ref: Bean/23333

Megan Barr
Consultant Planner
Kāpiti Coast District Council

RM240112 – RESPONSE TO SECTION 92 FURTHER INFORMATION REQUEST

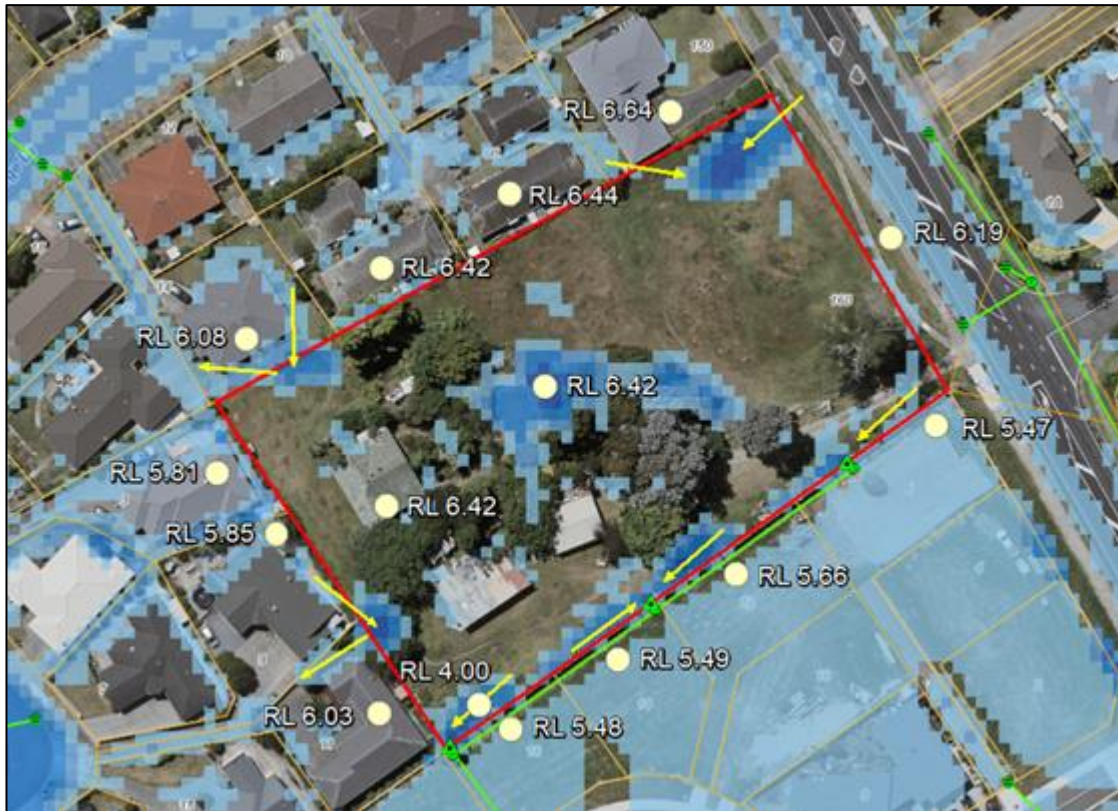
18. *In order to assess the application against Policy NH-Flood-P13 and associated rules, the application has not provided information demonstrating whether the development will redirect floodwater onto adjoining sites and what those impacts might be. The earthworks plan and example as shown in Figure 13 show the land being raised in what is shown as a ponding area to a level higher than the surrounding properties therefore potentially redirecting ponding or surface flow onto properties outside the development site.*

Please provide information demonstrating what the effects are of the land raising on both the displacement of flood waters onto adjoining properties and also impacts on natural drainage and/or surface flow from the development site to the neighbouring properties i.e. from higher land to lower land [i.e. Changing the natural servitude].

The earthworks proposed will shape all finished ground levels towards the central stormwater disposal area.

Updated flood information from Awa shows the direction of flow within the ponding areas (please disregard the levels which are in Wellington Datum 1953 and have not been provided by Awa in VD16). Full email correspondence is attached.

The topographical data and site inspections of the boundary, show that water is not entering 160 Mazengarb Road from surrounding properties as indicated by the yellow arrows in Awa's diagram above. The data does show ponding entering the site from Mazengarb Road which our design proposes to prevent by raising the entrance to the new development.

When Niu Sila Way was developed, stormwater pipes were installed to ensure ponding within 160 Mazengarb Road, along the southern boundary was conveyed through Niu Sila Way due to the raised ground level and construction of the retaining walls preventing ponding escaping the site.

Whilst the ground level at No. 160 Mazengarb Road is being raised above Niu Sila Way, the site will be shaped so that it falls towards the centre of the site, conveying runoff away from the neighbouring properties.

The localised ponding within 160 Mazengarb Road, due to rainfall on the site has been catered for within the design which controls all stormwater generated from the new development.

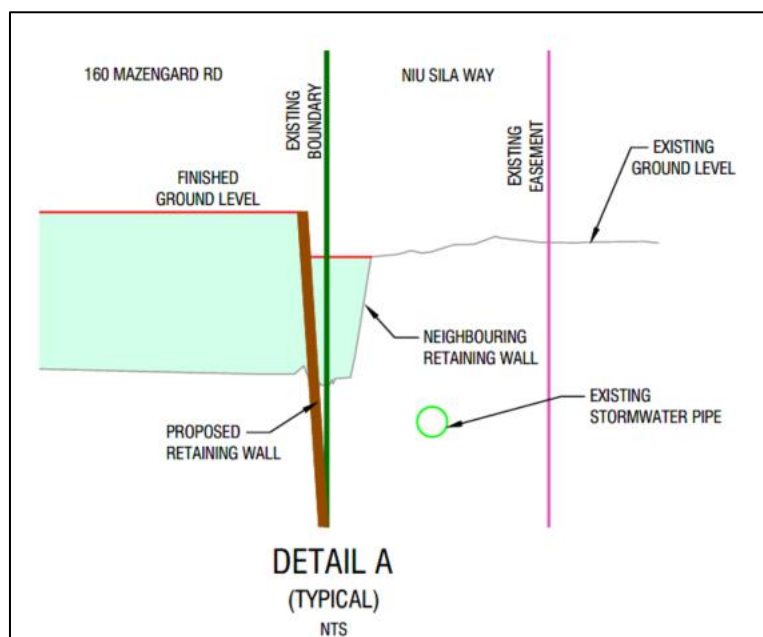
36. Please provide an assessment of the effects of the proposed earthworks to be undertaken within the adjoining properties at Niu Sila Way on the water drainage easement labelled 'H', 'I', 'J', 'K' on Record of Title 1030162. Please advise whether Council's Water and Wastewater team has been consulted about the proposed fill earthworks within the easement.

Consultation had not been undertaken with Council's Water and Wastewater Team with respect to the water drainage easement prior to the meeting on 05 September, where the easement was discussed with Paul Busing who confirmed that there was no fundamental issue with the works within the easement when considering that the pipes were installed to capture water from No. 160 Mazengarb Road, when Niu Sila Way was developed, as the retaining walls stopped the flow of water. As ground level at No. 160 Mazengarb (and the strip of land at Niu Sila Way) is being lifted, and falls inward, water is directed towards the centre of the site and the easement is effectively made redundant, refer to diagram below which has been excerpted from Sheet 4 of the Scheme Plan.
